Contract Change Order # 1

Project Name: <u>LLWWTP Maintenance Building Addition</u>	Project Number: <u>165415</u>
Project Location: <u>Lynn Lane WWTP</u>	Date of Application: <u>Monday, January 23, 2017</u>
Contractor: <u>Builders Unlimited</u>	Submitted By: <u>Eldon Fenderson</u>

RFI

Subject: BA WWTP Plumbing Rough In

Drawing: M 1.1

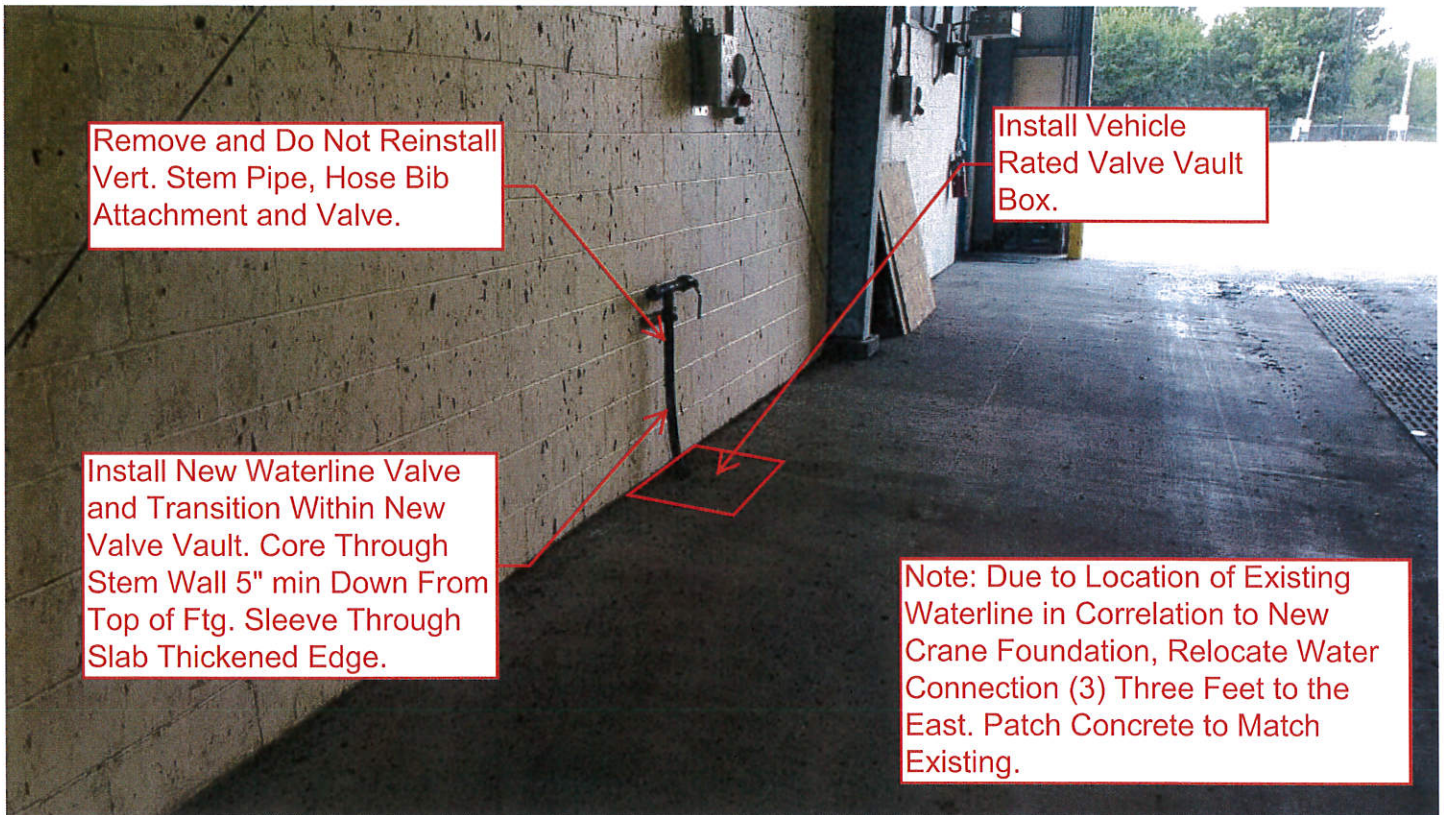
We would request that the 1 1/4 inch water line be routed overhead and insulated after the installation of the shut off valve at the tap. This will not interfere with the monolithic slab and footings and reinforcing steel. All other aspects will remain the same. It will be supported from the new building structure and be insulated.

The above purposed resolution is rejected, however please see attached for an alternate method of installation. After reviewing the existing building foundations and bearing material, COBA does not want to disturb the bearing material supporting the existing building. The existing waterline inside the building is to be excavated such to accommodate a drivable valve box to allow for a transition through the top of the stem wall footing. The hose connection and vertical piping shall be removed and not reinstalled. See attached plans for further clarifications.

12" x 12" BOX ASSEMBLY

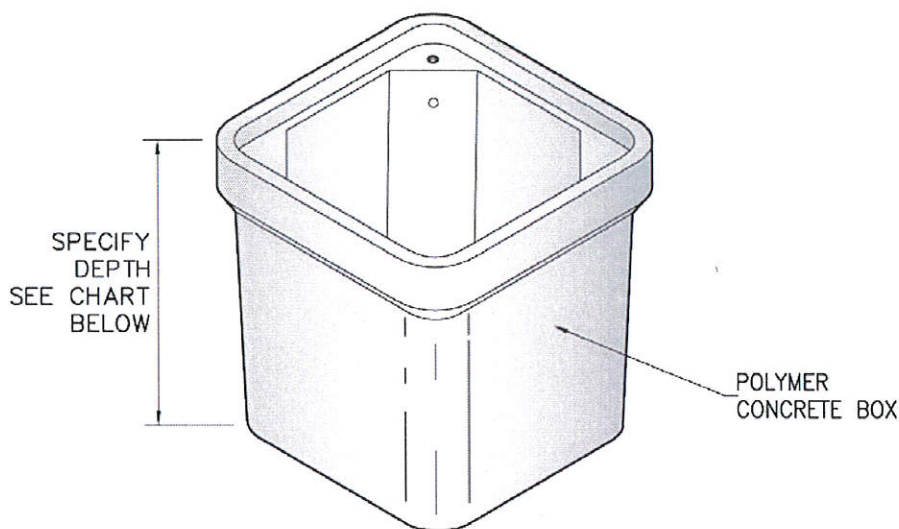
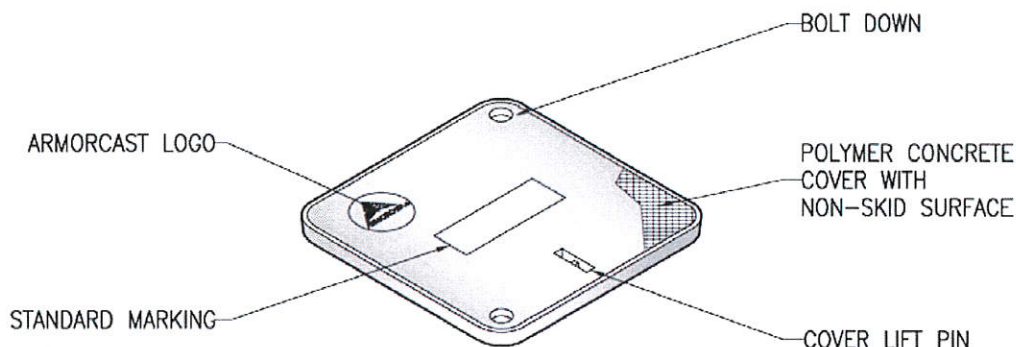
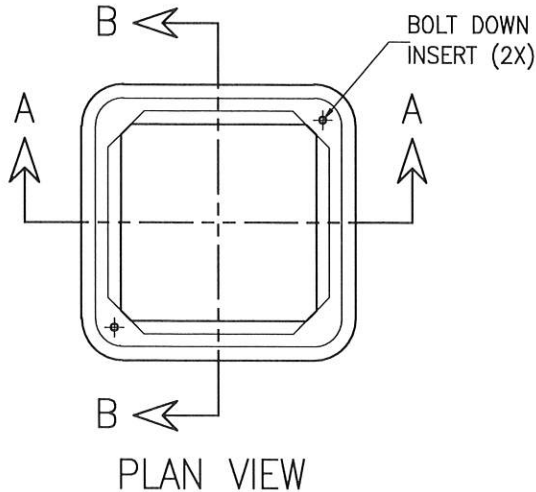
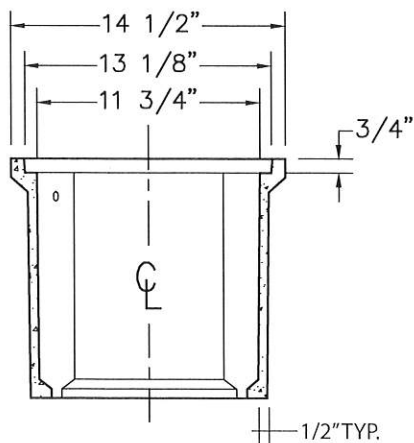
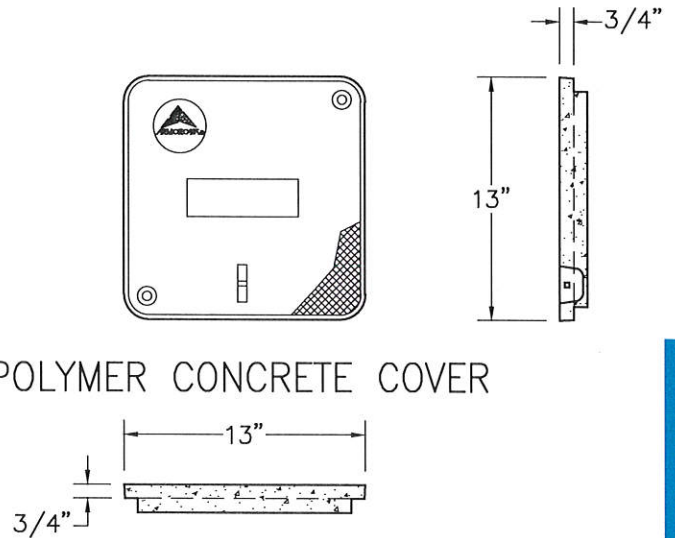
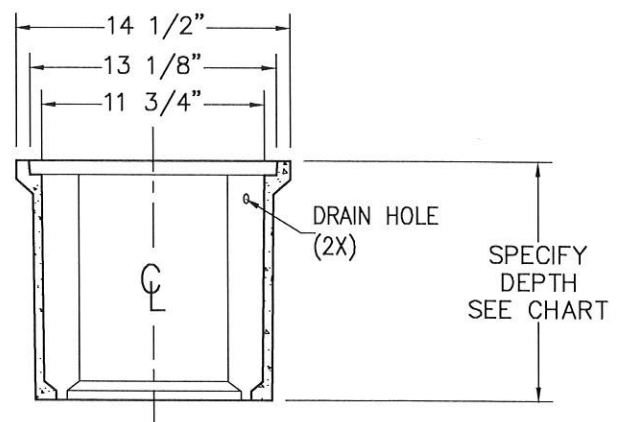
The City's response to RFI No.2 now requests the demolition of the existing above ground piping and the installation of a 12 x 12 box assembly, core drilling the concrete, and installing the shut off valve in the box. The additional cost for this revision is as follows:
